# UNITED STATES PATENT AND TRADEMARK OFFICE

10/816,192

<b>Office Action Summary</b>	<b>Application No.</b> 10/816,192	<b>Applicant(s)</b> JEONG ET AL.	
	<b>Examiner</b> Matthew W. Ing	<b>Art Unit</b> 3637

## **DETAILED ACTION**

From Vardon (2002/0190620)

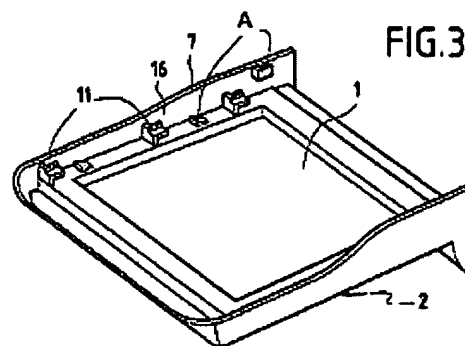
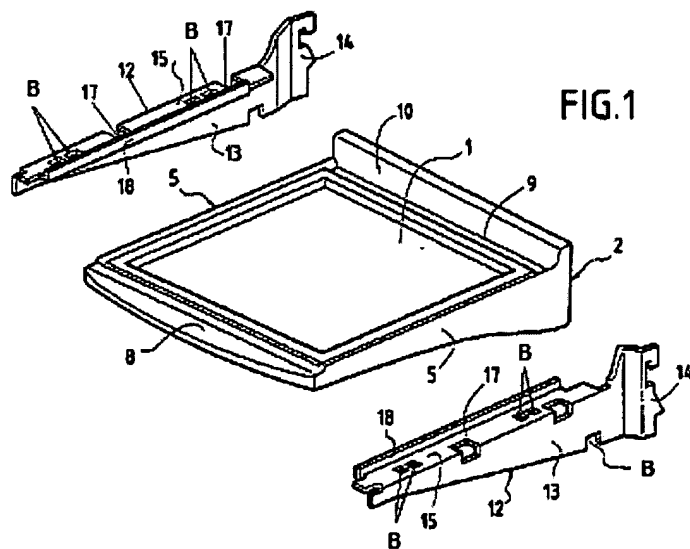
12. Claims 1-3 and 7 are rejected under 35 U.S.C. 103(a) as being unpatentable over Lye (6,227,636) in view of Vardon (2002/0190620). Lye teaches the structure substantially as claimed, including a main body (2) formed with a storage compartment (6), wherein said storage compartment has a plurality of interval adjusting holes (45) disposed at a side of an inner wall; a door (7) hingedly connected to the main body; at least one shelf (25) provided inside said storage compartment (see Figure 1), said shelf having a hook portion (38) selectively coupled to one of the plurality of the interval adjusting holes; the only difference being, Lye fails to teach a shelf comprising a glass on which foodstuffs are laid; a glass supporter coupled to edges of the glass, said glass supporter comprising a main portion coupled to the edges of the glass, and a bracket supporter extended downward at opposite sides of the main portion and supported with the supporting bracket; a pair of supporting brackets provided in opposite sides of the glass supporter

and supported onto a wall of the storage compartment; and a coupler coupling a lower part of the glass supporter with the supporting bracket. Vardon, however, teaches a refrigerator shelf comprising a glass (1) on which foodstuffs obviously can be laid; a glass supporter (2) coupled to edges of the glass, said glass supporter comprising a main portion (6) coupled to (3) the edges of the glass, and a bracket supporter (7) extended downward at opposite sides of the main portion (see Figure 3) and supported with the supporting bracket (see paragraph 43); a pair of supporting brackets (12) provided in opposite sides of the glass supporter and supported onto a wall of the storage compartment (see paragraph 43); and a coupler (Item A - see Figure 3, Annotated) coupling a lower part (7) of the glass supporter with the supporting bracket. It would have been obvious to one of ordinary skill in the art to include the shelf, glass, glass supporter, bracket supporter, supporting brackets, and coupler of Vardon in the refrigerator of Lye in order to provide the user with shelves that are hygienic, lightweight, and easily cleanable, thereby providing the structure substantially as claimed.

13. Claims 4-6 are rejected under 35 U.S.C. 103(a) as being unpatentable over Lye (6,227,636) in view of Vardon (2002/0190620) and Maruta (2001/0030491). Lye and Vardon teach the structure substantially as claimed above, including a plurality of couplers (Item A – see Figure 3, Annotated) formed at the bracket supporter (7) and holes (Item B – see Figure 1, Annotated) corresponding to each coupler, said couplers and holes comprising “coupling units”; a plurality of supporting ribs (11) formed between the couplers; and a supporting bracket (12) provided with a bending portion (15) fitted to the supporting ribs via notches (17), and supporting the main portion (see Figure 1); the only difference being, Lye and Vardon fail to teach the use of coupling units comprised of coupling bosses formed at the bracket supporter, with holes in the supporting bracket corresponding to each boss, and screws penetrating said holes and accommodated in said bosses. Maruta, however, teaches the use of coupling units comprising a plurality of coupling bosses (11b) formed at depending portions (12, 13) of a structure (10); penetrating holes (22a), in positions corresponding to each boss (see Figures 2-3), formed in an object (21) to be attached to said structure (10); and couplers comprising a plurality of screws (30) penetrating said penetrating holes and accommodated in said coupling bosses (see Figure 4). Since the coupling units of Lye as modified by Vardon, and the coupling units taught by Maruta, are both equivalent alternative structures used to accomplish the same purpose, it would have been obvious to one of ordinary skill in the art to replace the coupling units of Lye as modified by Vardon with the coupling bosses, penetrating holes, and couplers taught by Maruta in order to increase the structural rigidity of the connections between the supporting brackets and the glass supporter, thereby providing the structure substantially as claimed.
